P262: NV44/G3-64, TSOP MEMORY ×16

REV HISTORY

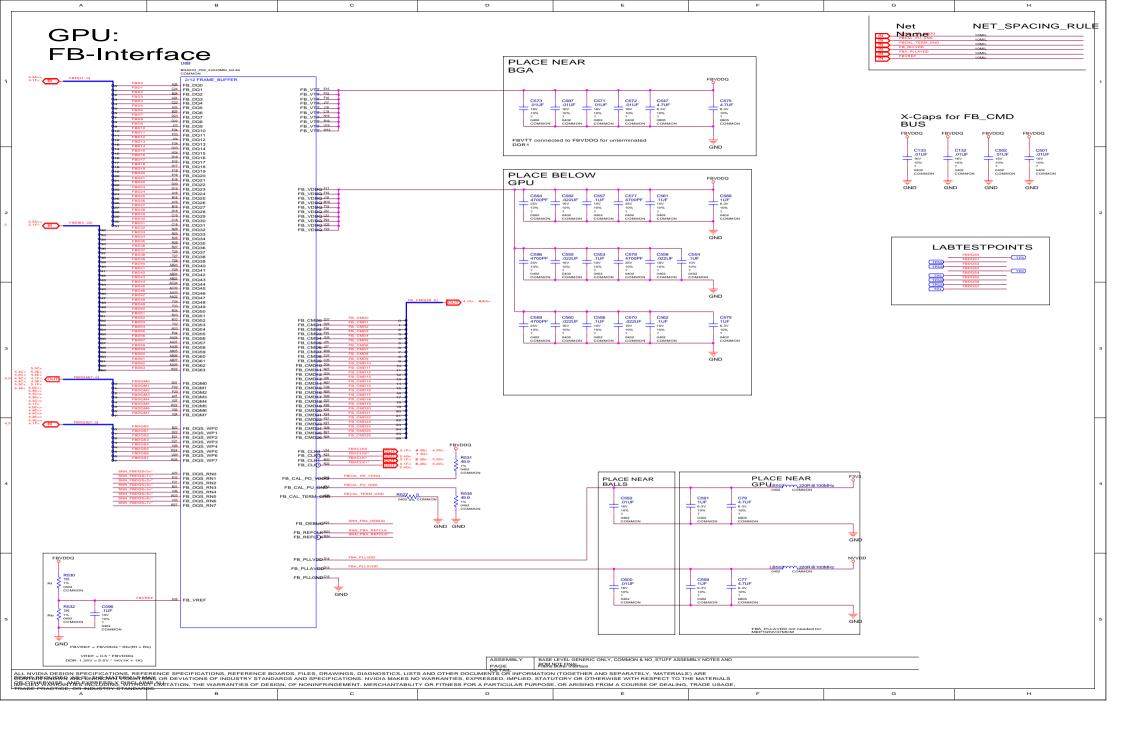
Changed TMDS_PLLVDD to PLLVDD rail of NV44 Changed RSET values for DACA and PACE Changed DACB RSET FET to a dual package with GPIO11 control-Macrovision Added F3V3 bypass to PLLVDD linear regulator Changed location of R62
